Access Compliance Report Public Rights-of-Way (Pedestrian Signals)

Main Street: CERRITOS_AVE Cross Street: GILBERT_ST Location: NW

ADA ID: SGRK210923133012 Signal Type: One Push Button-Non APS Overall Compliance: No Severity Scores: BTN 1: 0 BTN 2: N/A No BTN: N/A

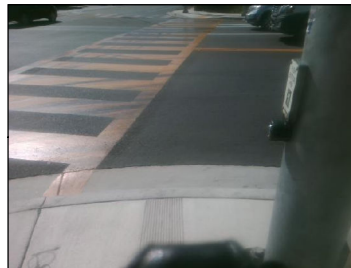
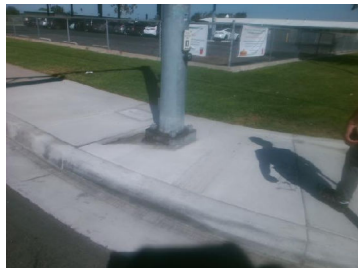
OC Std/PROW: MUTCD 4e.08

Possible Solutions: Replace Signal Push Button With APS Button. Remove & Relocate Sign.
